Westinghouse

SUBJECT: Transmittal of Westinghouse Responses to Open Items Identified in the AP1000 Draft Safety Evaluation Report

AP1000 DESIGN CERTIFICATION REVIEW

Draft Safety Evaluation Report Open Item Response

Figure 15A-1

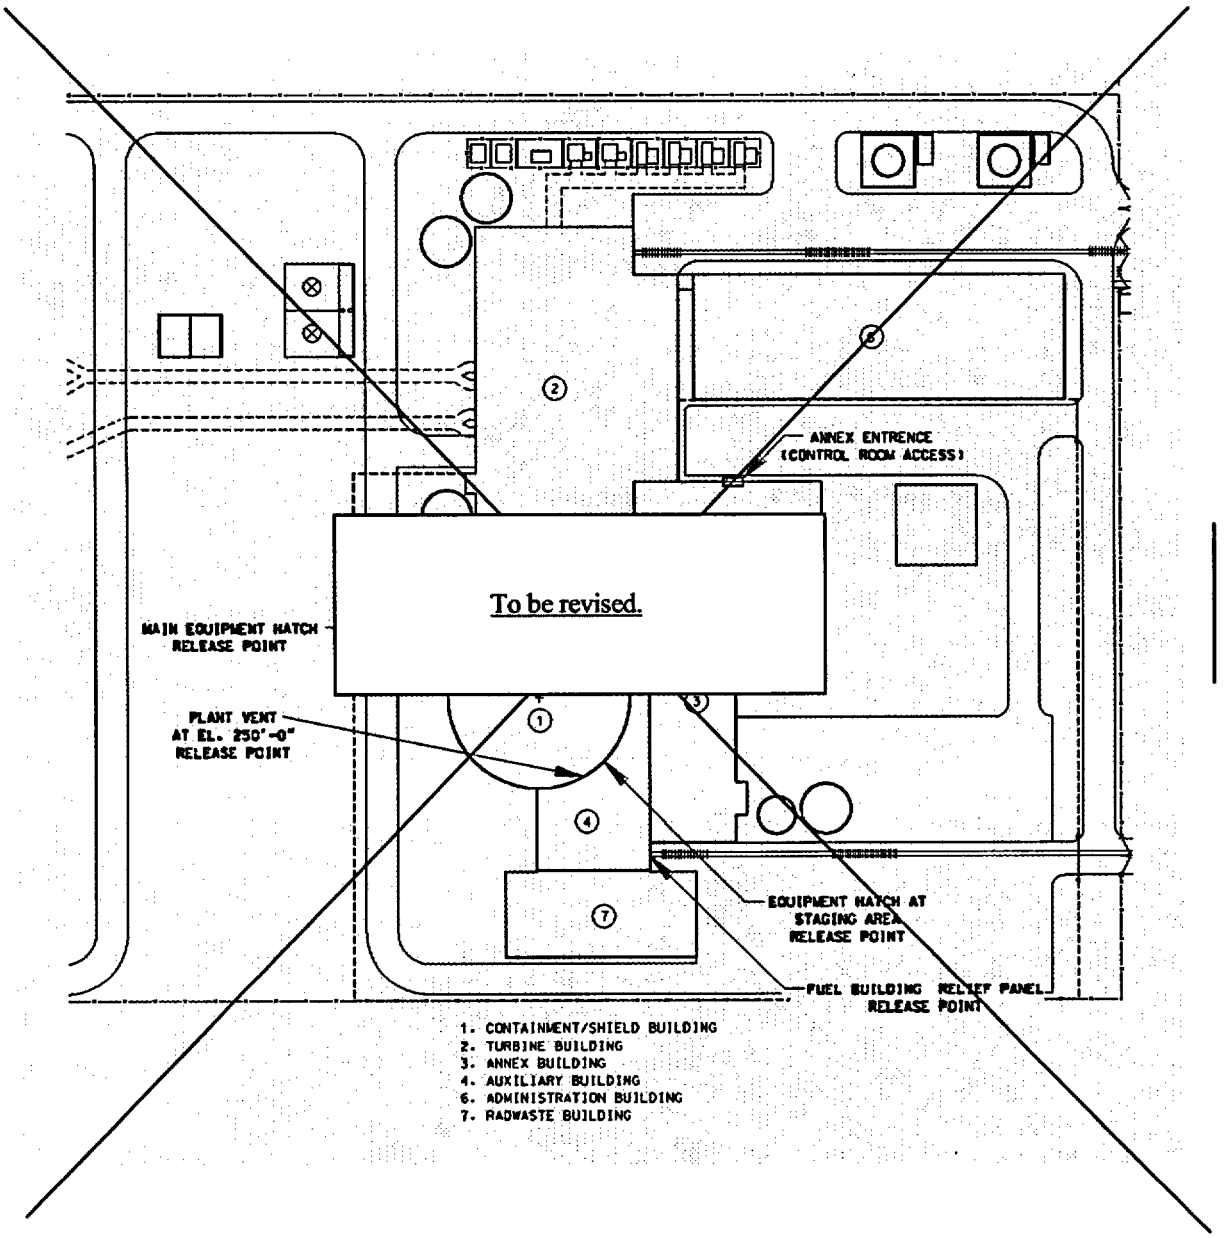
An underlying issue regarding this exercise, and part of the original NRC RAI related to this issue, is whether the control room χ/Q values are being approved for AP1000 as part of Design Certification. Unlike the offsite χ/Q values that were identified as site interface parameters that the COL applicant would later verify for their site, the control room χ/Q values were not identified as a site interface for either the AP600 or AP1000. Westinghouse agrees with the NRC that control room χ/Q values should be identified as a site interface parameter. Thus a COL applicant would verify as part of the COL process that the calculated control room χ/Q values for their site are bounded by those assumed in the DCD dose analysis. However, unlike the site boundary χ/Q values that are based solely on the site meteorological data, the control room χ/Q values are determined based both on site meteorological data and assumptions related to plant design features and layout. Westinghouse believes that the assumptions related to the plant design features are important in ultimately determining acceptable control room doses for design basis accidents, and therefore should be approved as part of Design Certification.

The locations of the potential release points for a Loss-of-Coolant Accident and their relationship to the main control room air intake and the personnel access door are shown in Figure 15A-1. Figure 15A-2 shows the locations of the potential release points associated with other postulated accidents relative to the possible paths for air entry into the main control room.

Figure 59-2

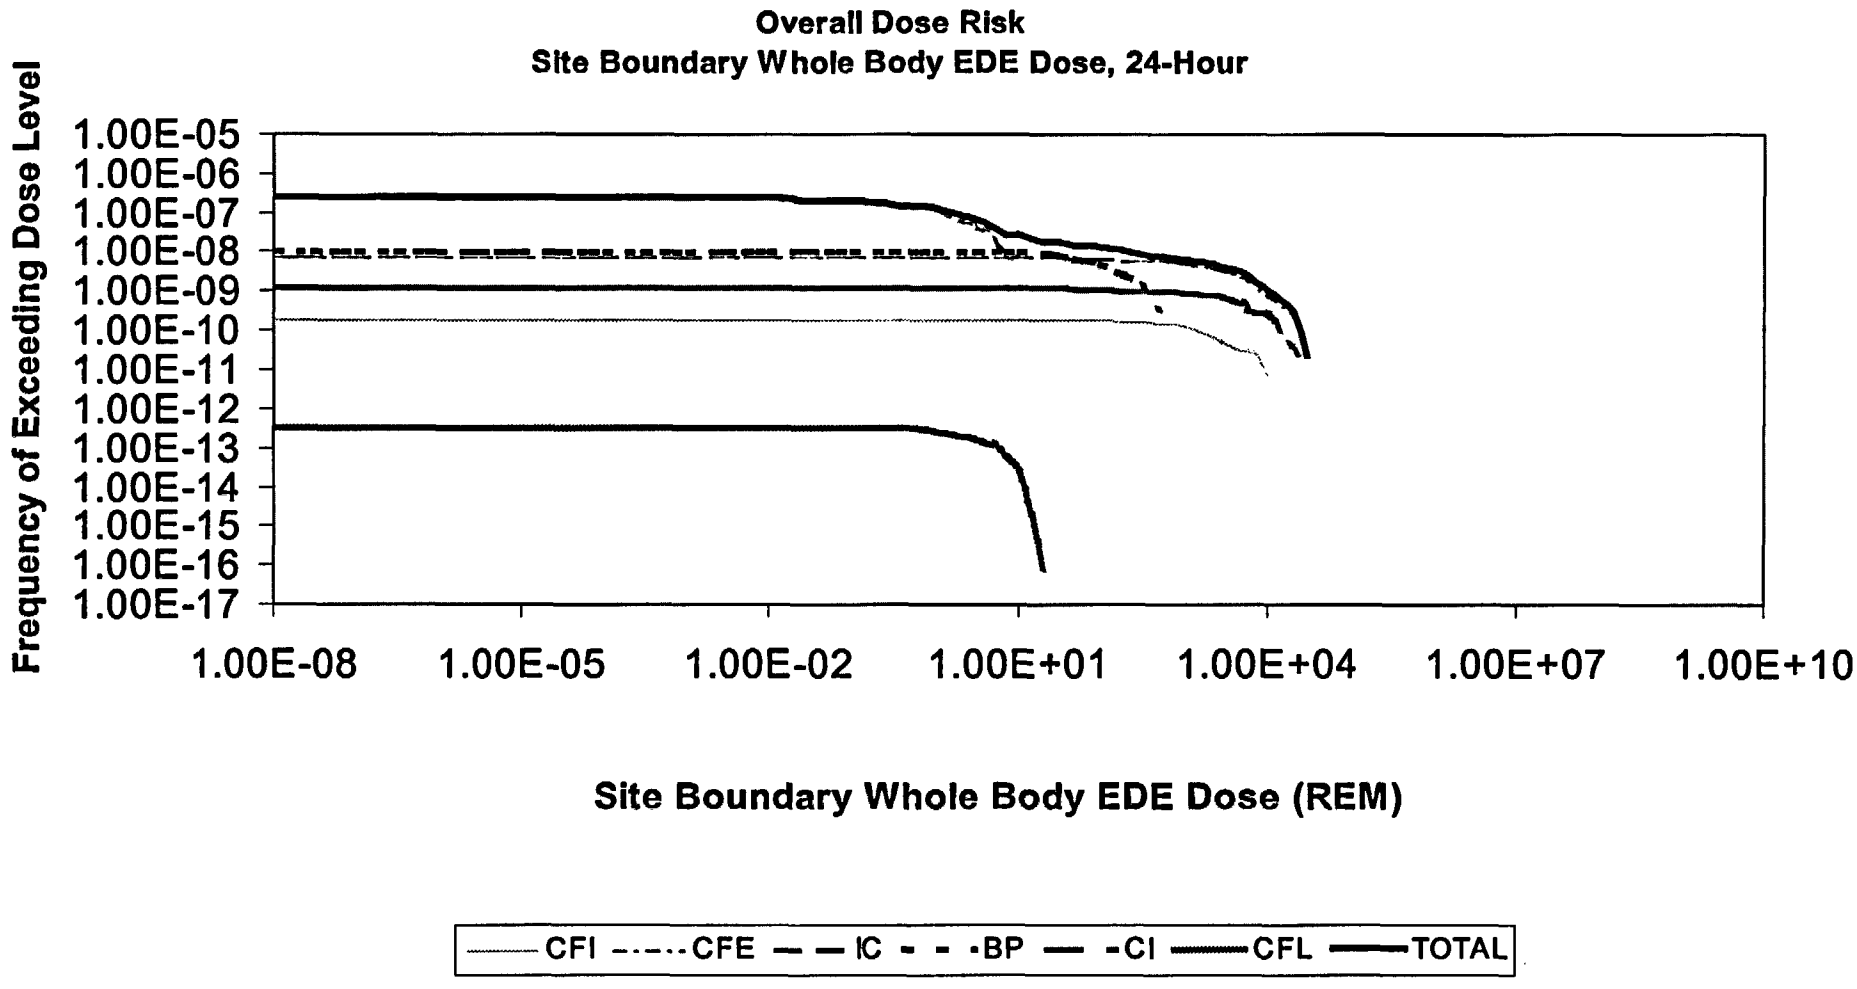
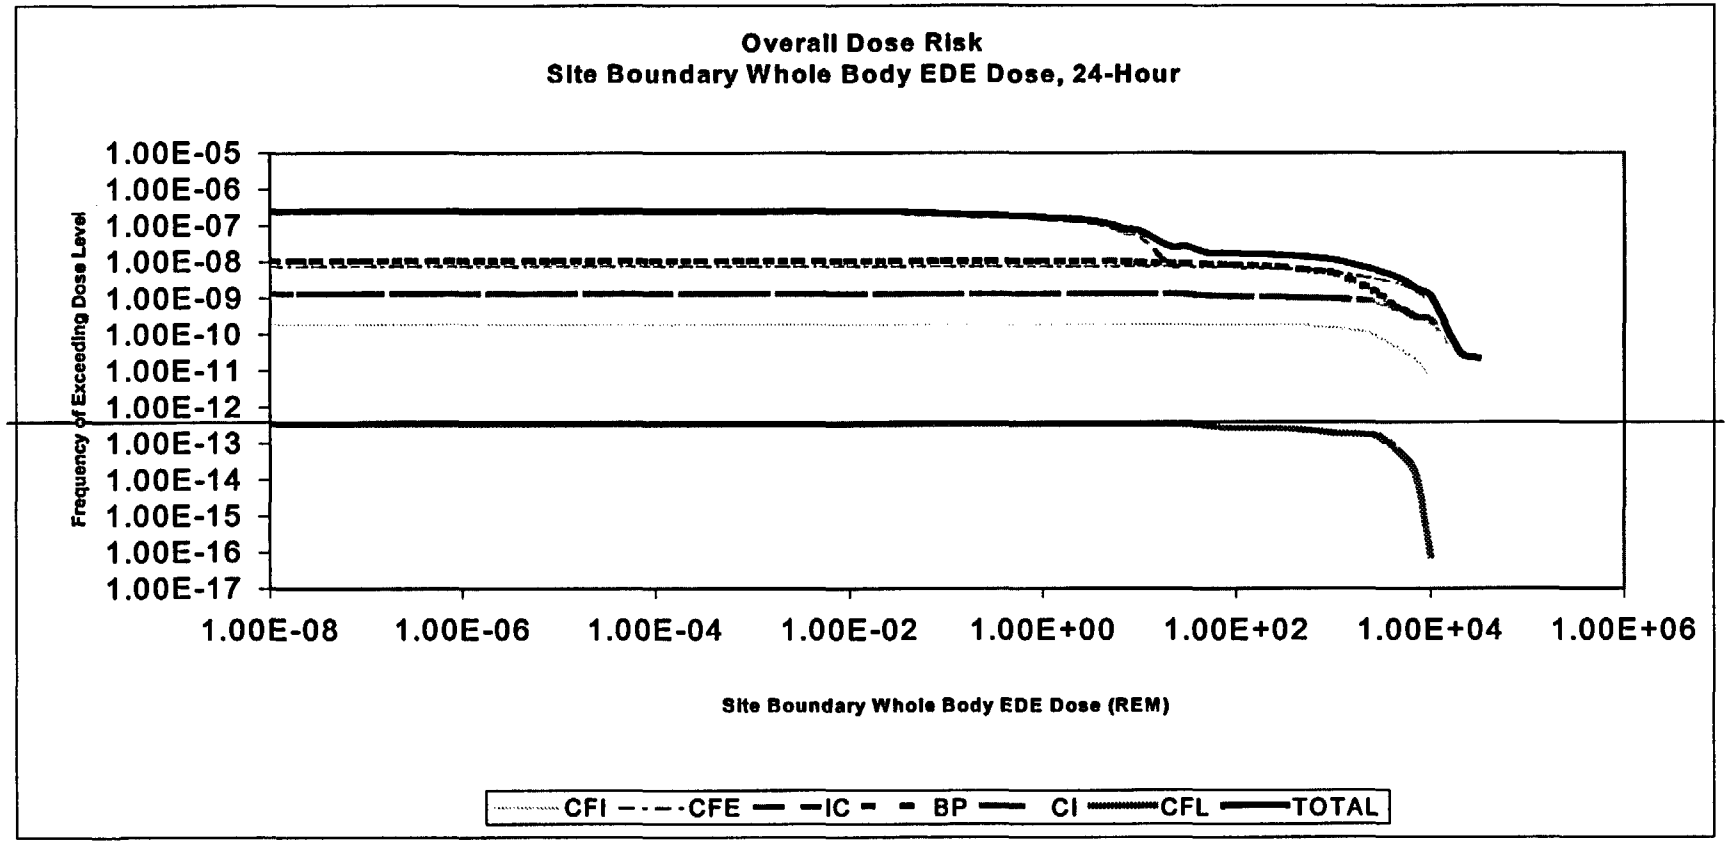
The accident sequences used to represent the various release categories are identified and briefly described in PRA Chapter 45. Additional sequence information is provided in PRA Chapter 34. The basis for selecting the representative sequence for each release category is not provided. Such information is necessary in order to confirm that the sequence selected to represent each release category is reasonably representative of the collection of sequences assigned that category, in terms of the magnitude, timing, energy, and elevation of release. Based on the limited information that was provided, the staff noted a number of inconsistencies. Specifically, for release category CFE releases from the ADS Stage 4 valves enter directly into containment rather than into the IRWST, and given the location of the valves relative to the containment shell, would not result in containment failure from diffusion flames as assumed in the PRA. For release category CFL containment failure is assumed at 3 hours, which is inconsistent with the time frame for late containment failure. Also, important details impacting the release characteristics need to be documented, such as whether an additional decontamination factor is credited in determining the source term for SGTR events (as it was in AP600), and the containment isolation failure location and size assumed for containment isolation sequences. This is Open Item 19.1.10.3-I.

The total at-power risk from a postulated release of fission products (the 24-hour, site boundary effective dose equivalent (EDE) is ~~5.15E-05~~**1.83E-04** rem per reactor-year. For shutdown, this risk was calculated to be 7.1E-05 rem per reactor-year for AP600. For AP1000, this shutdown risk could be estimated as 9.7E-05 rem per reactor-year (estimated the same way as shutdown LRF in Table 59-15). Table 59-16 and Figure 59-2 summarize the plant dose results.

~~Early containment~~**Containment bypass** failures account for ~~61~~**79** percent of the dose risk. These types of failures are usually assumed as a result of ~~sump flooding failure, vessel failure, or core reflooding failure~~**steam generator tube rupture**. A less conservative analysis of the ~~early~~ containment bypass failures may show a smaller frequency, and, as a result, a smaller dose risk.
